**Z-24
(2010)**

**BOUNDARY & TOPOGRAPHIC
SURVEY FOR
EAST COBB UNITED
METHODIST CHURCH
LOCATED IN LAND LOT 95
116th DISTRICT, 2nd SECTION
COBB COUNTY, GEORGIA
SCALE: 1"=50'**

PETITION NO: Z-24

PROPOSED USE: Religious Facility With
An Electronic Reader Board Sign

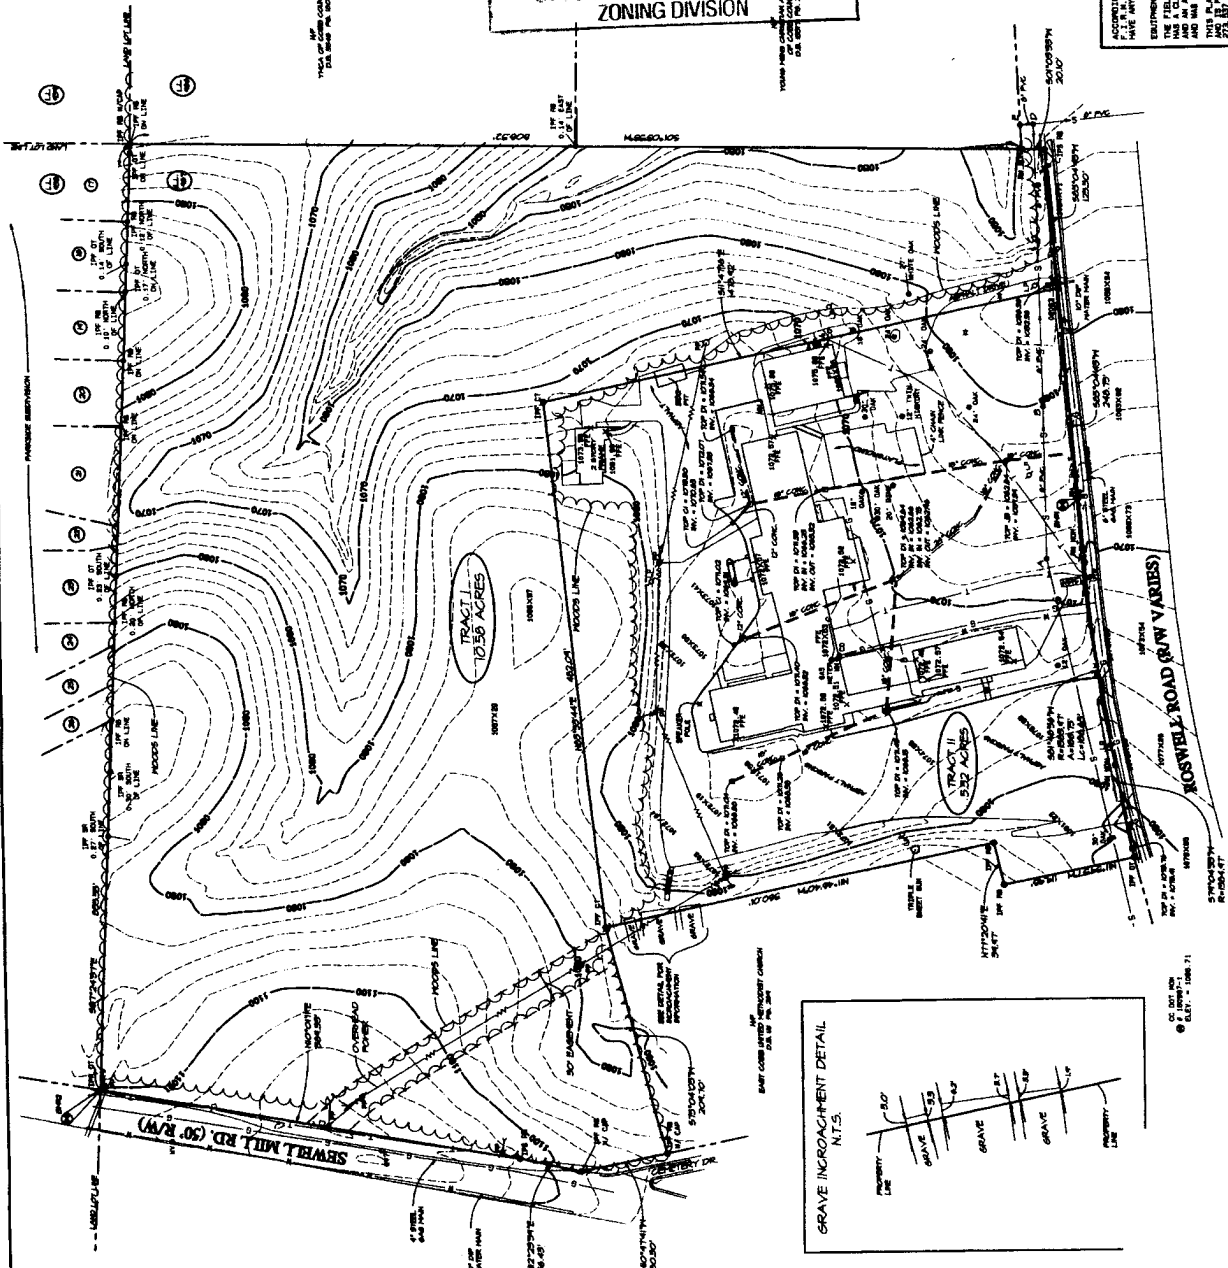
Additional Comments: Proposed sign must be a minimum of 10' from the edge of the 20' sanitary sewer easement
